<h1 style="margin: 0;">Product Change Notice</h1> <p style="margin: 0;">(PCN Tracking Number: EE-QR-230213-01)</p> <p style="margin: 0;">Version: 1</p>

Customer:	ALL Customers		
Renesas Product Type:	RA(RA6M3)/SYNERGY(S5D9) 176pin-LQFP products. (full list on p.7)		
Description of Change:	Change of back-end factories (assembly & test) Change of assembly materials Please refer to p. 2 for more details		
Reason for Change:	To ensure stable supply		
Identification:	Identifiable thru production history data via trace code or product label		
Schedules:	Sample order deadline:	e/o Mar. 2023	
	Sample availability:	b/o Jun. 2023 (upon request)	
	Reliability report:	available (upon request)	
	Requested approval:	e/o May 2023	
	Change Implementation:	b/o Jul. 2023 onwards	
Anticipated Impact:	Fit & Form:	Some changes in dimension (refer to p. 2 -6)	
	Function:	No change	
	Quality & Reliability:	No impact	
	Part Number:	Change	
Doc. No.:	EE-QC-PCN-CR-23-0018		
Internal Reference:	IMO-AB-23-0009

24x24mm 176pin LQFP package drawing (Change)

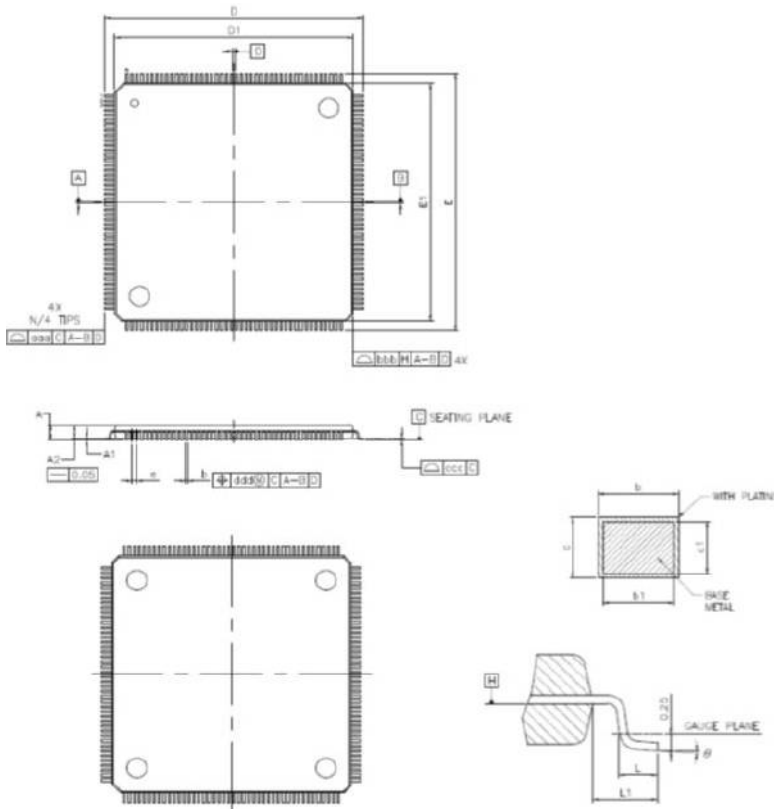
2. DIFFERENCE OF SPECIFICATION'S DETAIL (2)

RENESAS Code : PLQP0176KJ-A

SYMBOLS	MIN.	NOM.	MAX.
A	—	—	1.60
A1	0.05	—	0.13
A2	1.35	1.40	1.45
D	26.00 BSC		
D1	24.00 BSC		
E	26.00 BSC		
E1	24.00 BSC		
N	176		
e	0.50 BSC		
b	0.17	0.22	0.27
b1	0.17	0.20	0.23
c	0.09	—	0.20
c1	0.09	—	0.16
θ	0°	3.5°	7°
L	0.40	0.60	0.75
L1	1.00 REF		
H1	0.20		
H2	0.20		
H3	0.08		
H4	0.08

Appearance : 24x24mm 176pin LQFP package

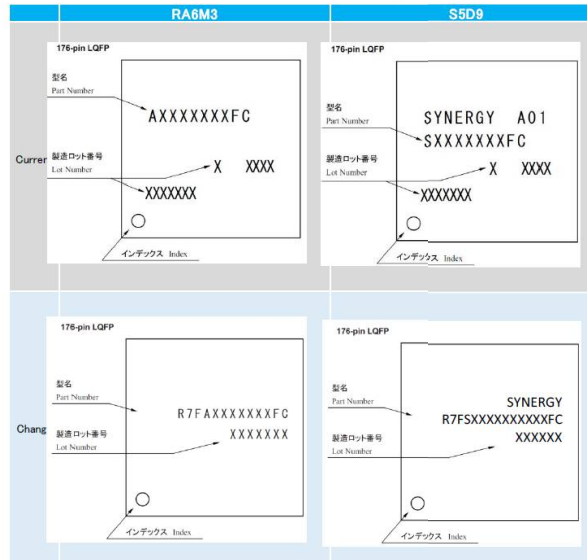
2. DIFFERENCE OF SPECIFICATION'S DETAIL (4)

※Marked character is reference example

*There is no WS notation in the actual product

Packing specification (Tray)

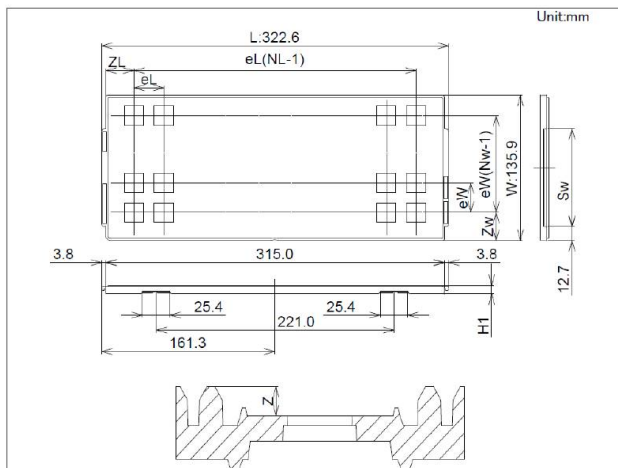
Tray Code	Current		Change	
	LQFP24x24x1.4		EAC242401-10	
Position dimension of cells	Z	1.50		
	Zw	20.70		
	ZL	20.70		
	eW	31.50		
	eL	30.40		
	Sw	92.1		
Thickness (mm)	H1	7.62		
Number of cells	Nw	4		
	NL	10		
Maximum storage pcs IC/Tray	40			
Maximum storage pcs IC/Inner box	320	240		
Material	Carbon PPE			
Heat resistant temperature	135°C MAX			
JEDEC/Custom	JEDEC			
Surface resistance	Less than $1 \times 10^{11} \Omega/\square$
